Aftertreatment DPF Combustion Housing

SB-10044333-9095

LEU, MRU
MP7

PI0772, Aftertreatment DPF Combustion Housing

W2071581

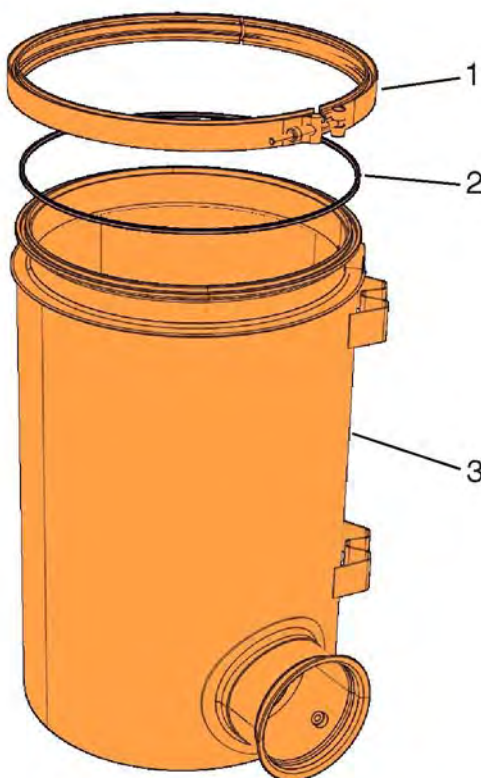
Campaign PI0772 is available for the replacement of the Aftertreatment DPF (Diesel Particulate Filter) combustion modules on certain Mack LEU and MRU chassis built between August 9, 2010 and September 29, 2010. The affected combustion modules have the potential of cracking from thermal expansion during the Regeneration process. The housing improvements includes an improved welding process, and new base material with a greater wall thickness which will prevent issues with fatigue of the base material and welds in the combustion housing.

Aftertreatment DPF Combustion Housing Kit 21797818			
Item	Qty	Part Number	Description
1	1	21048521	V-Band Clamp
2	1	21424458	DPF Body Gasket
3	1	21797816	Combustion Module
